Conditional Use and Site Plan request for an addition serving as an orchestra room.

Hudson Planning Commission	CONDITIONAL USE/SITE PLAN REVIEW – HHS ORCHESTRA ADDITION
Case No. 2025-507	June 9, 2025

Approve the Conditional Use and Site Plan application for Hudson High School, Case 2025-507, according to plans received May 16, 2025 subject to the following conditions:

Figure 3

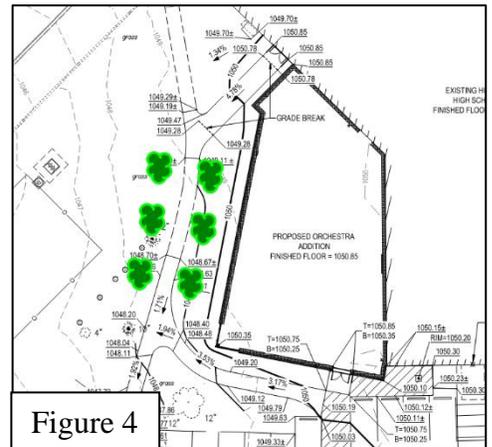
Staff notes five existing mature trees would be removed for the addition (see Figure 3). Staff recommends a row of trees be planted along the walkway to compensate for the loss of trees as depicted in Figure 4.

1. Extend the walkway to connect to the existing path along Malson athletic center as depicted in Figure 1.
2. Plant additional trees along the walking path to offset the loss of mature trees as depicted in Figure 4.
3. A fence shall be constructed around the adjacent dumpsters to comply with Section *1207.04(m) Screening and Landscaping for Service Structures*.
4. The comments of Assistant City Engineer David Rapp’s review letter dated June 2, 2025 shall be addressed.
5. The applicant shall install silt fencing and/or polypropylene fencing to mark and protect the approved clearing limits, which shall be maintained by the applicant.
6. Satisfaction of the above conditions prior to scheduling of a preconstruction meeting with City officials and no clearing or construction of any kind shall commence prior to the issuance of a zoning certificate.

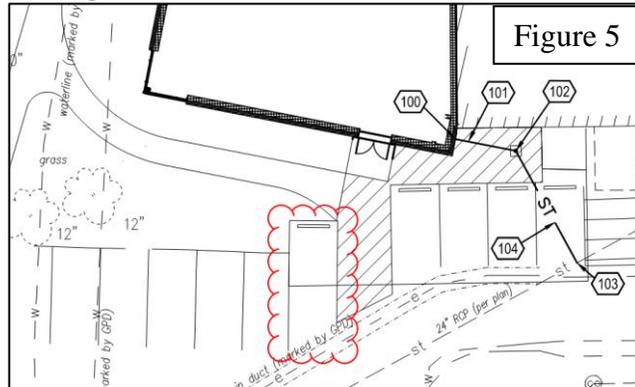
The proposal does include some minor reconfiguration to the existing parking. Staff notes one parking stall is proposed west of the rear door access (see Figure 5). This stall alignment places it well forward of the abutting stall creating an awkward turning movement. Question if this stall can be shifted to the east to align with the adjacent stalls and shift the walkway to the west or combined with the adjacent existing pedestrian crossing.
